GUAM WATERWORKS AUTHORITY

Fire Hydrant Replacement – Phase I

GWA Project No. W19-002-BND

Response No. 3 to Contractor Inquiries

MANHOLE COVER, FRAME, & CONCRETE COLLAR

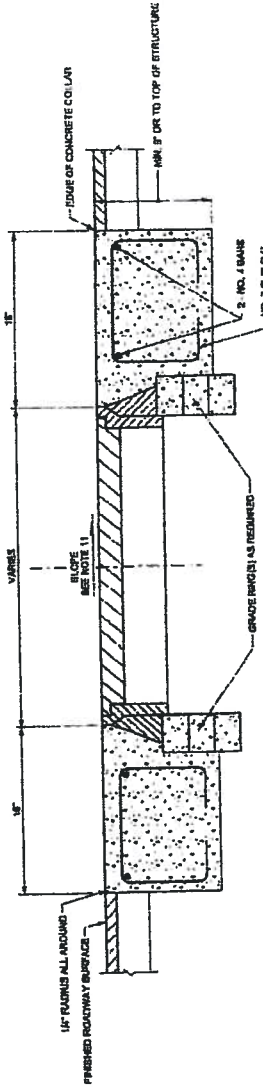
RFI No.	REFERENCE SECTION	QUESTION/INQUIRY AS SUBMITTED	GWA RESPONSE
1.		There is difference of valve collar concrete size between GWA and DPW Highway Division, which standard detail should be followed.	Bidders must follow the attached Department of Public Works standard detail.
2.		How many days of minimum concrete strength curing days?	See Specification 033000 - Concrete.

FOLLOW DEPARTMENT OF PUBLIC WORKS (DPW) CONCRETE COLLAR DETAIL 604-09 ON VALVE BOX & SEWER MANHOLES.
